**Service Information: Different compound color****Corteco No****12018929B**

46539824, 71718738

500, Grande Punto, Giulietta, Mito, Ypsilon

Figure 1: spotted version

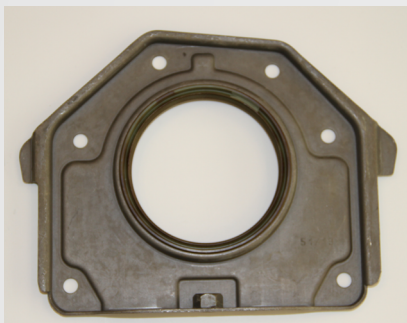
Comparing the p.n. 12018929B with the corresponding OEM references it is possible to notice a difference in the color of the rubber. The original article is perfectly green, while the p.n. 12018929B appears brown spotted: the cause of this difference is dictated

by the smoke created by the oven during the vulcanization process.

Despite this aesthetic anomaly, we can guarantee that the functionality of the product is perfect and that the quality of the compound and its tolerances are satisfied.

The p.n. 12018929B is interchangeable with the OEM product.
